Miranda House
UNIVERSITY OF DELHI

ACCESS AUDIT REPORT

2021 - 2022

PREPARED BY
EHS ALLIANCE SERVICES

1.1 APPROACH AND MAIN ROAD

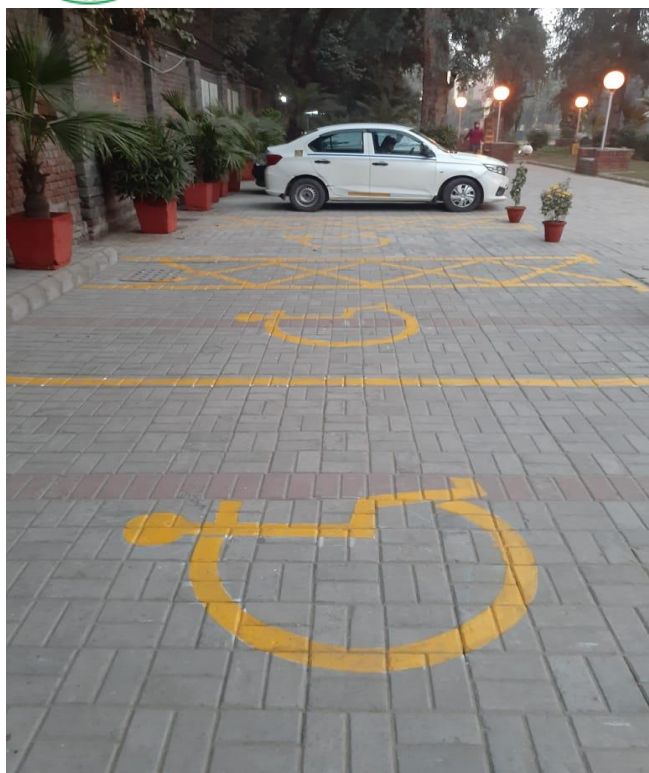
The building is easily accessible and is situated on a main road; nonetheless. Users who are blind are provided with tactile orientation.

- All of the entrance's surrounding area is levelled.
- Wheelchair users can easily approach the main entrance gate by using a kerb ramp that level the kerb to the road.
- The current signage is both in Hindi and English.
- A few signs have yet to be installed.

Here, more signage that has better colour contrast can be placed to ensure that it is easily seen by everyone.

- Make sure the approach routes are periodically maintained.
- For wheelchair users to move freely, the road in front of the entrance gate must be barrier-free.
- In order to help all types of people, signage must be appropriate in every way.

1.2 PARKING

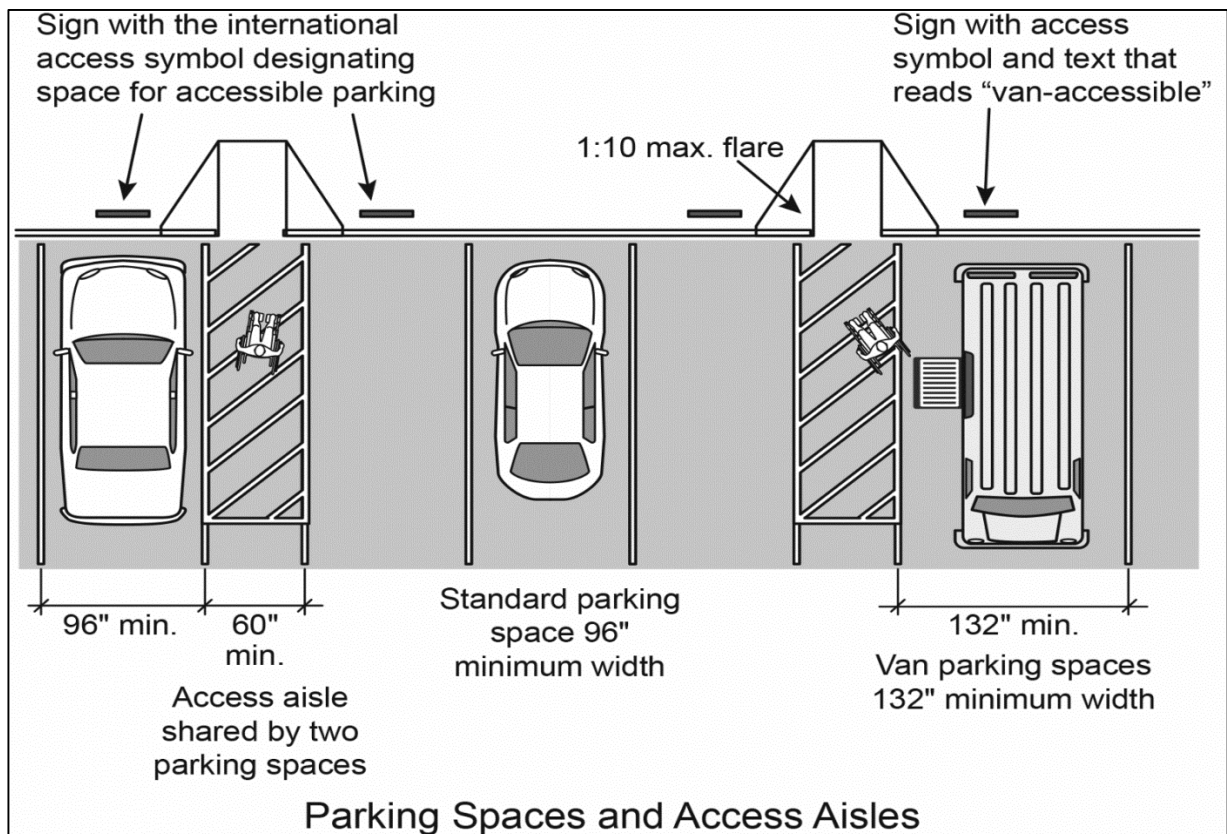
- Within the building's grounds, there is a parking area designated for those with impairments.
- There is unmarked parking available for personnel and visitors in front of the administration department building, respectively.
- Signage states that 2 parking slots are available;
- Unorganized parking of cars and two-wheelers.

- Parking spaces for wheelchairs are designated with the signage but it is not clearly visible from far distance. It should be highlighted with color contrast
- The provision of vehicle shelter is also necessary.

2.4 LIFT

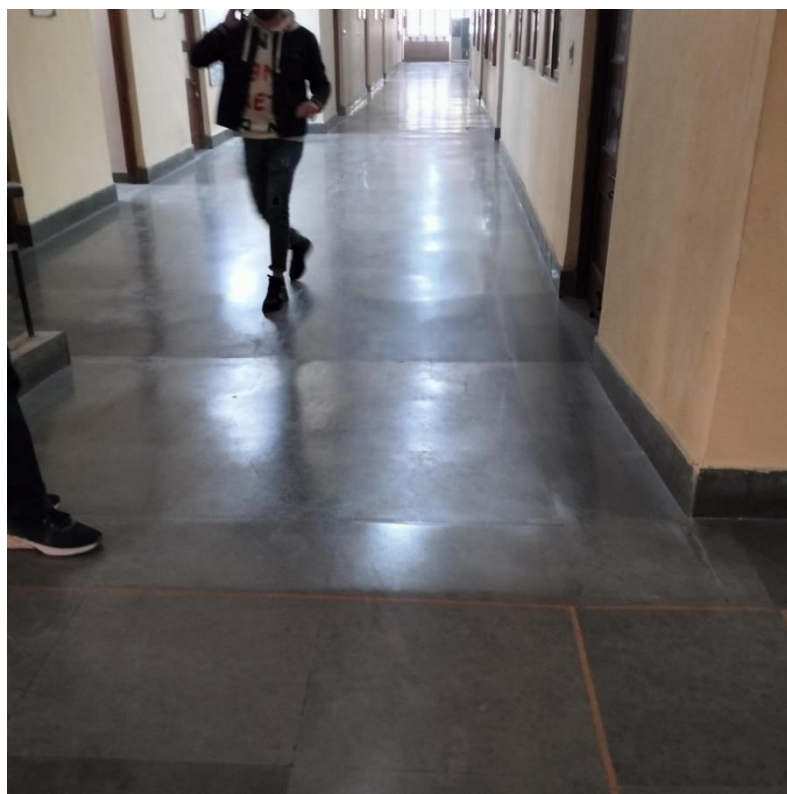
There is a lift in new building block that is open for faculty members and needy students.

- For the advantage of those with limited vision and hearing problems, think about offering an audio announcement system in addition to a visual display.
- The elevator needs to be clearly marked.
- At each entry, there needs to be clear signage pointing in the direction of the elevator.
- For a wheelchair user to independently utilise the lift, there needs to be a rear view mirror on the lift's back wall.
- Braille must be available on every elevator control for the benefit of those who are blind.

2.5 CORRIDORS AND DOORS

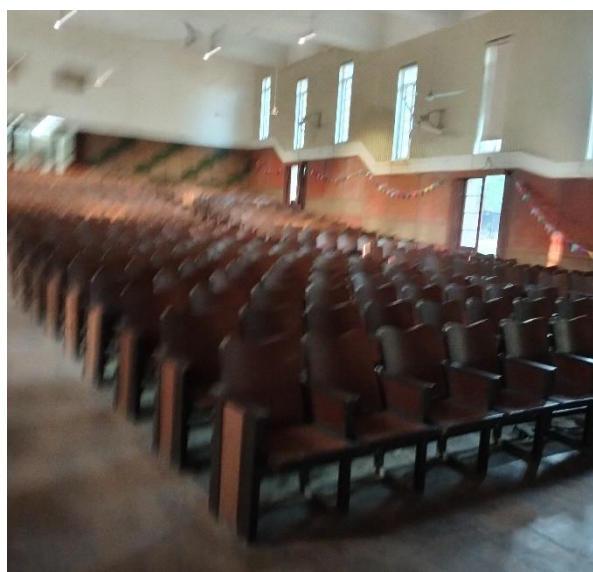
- The hallways are sufficiently wide (2300 mm), and no protruding objects lie in between.
- Displaying vibrant colour contrast.
- The illumination is just ok.
- Although slightly brilliant and reflective, the surface is not slippery.
- Doors with a handle height of 1200mm and a clear width of 1300mm.
- There is appropriate signage at the entrance.
- The door and floor have a poor colour contrast.
- •Signage that is currently displayed is too high and has poor colour contrast.

- Consider adding adequate, evenly distributed illumination to the hallways.
- In the hallways, it is advised to install guide rails on both sides.
- Give the entrance, walls, ceiling, and floor contrast in colour.

2.6 AUDITORIUM/ CLASS ROOM

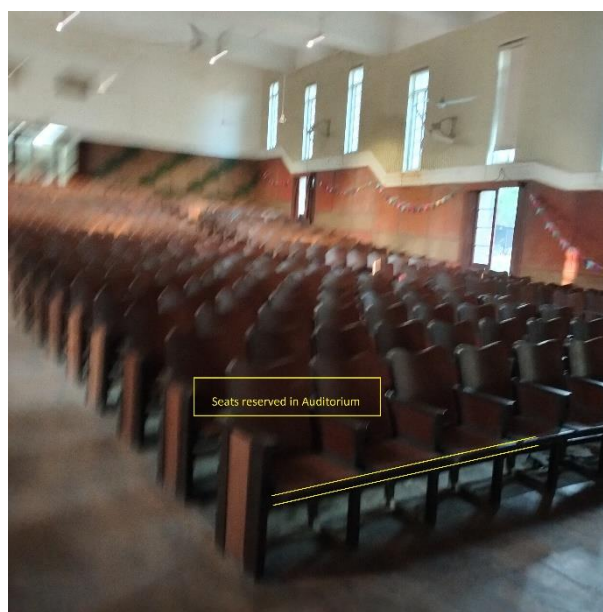
- The auditorium is located on the ground floor of the structure.
- Riser: 150mm, tread: 280mm, width: 900mm, inaccessible to people with disabilities
- Doors are 920mm wide.

- Stripes of different colours should be present on the steps.
- The steps shouldn't be as reflective as they currently are.
- A suitable ramp should lead to the stage.

2.7 LIBRARY

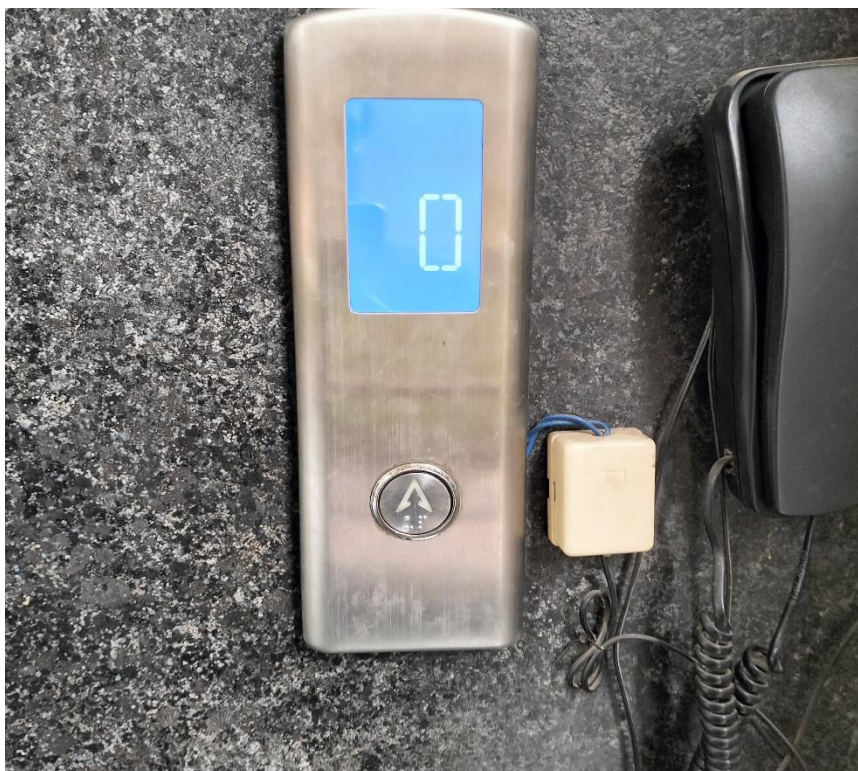
- Library space is offered in the same building.
- There are two ramps for entry.
- Library building is easy to reach but not that easy to access by visually impaired person, so library staff assisting in person to needy students as per the requirements.

- Ramps to enter into library, needs to be marked with proper color contrast.
- Regular maintenance of ramps and hand rails are suggested by the audit team.
- Signage needs to be clearly visible at clear height and colour contrasted.
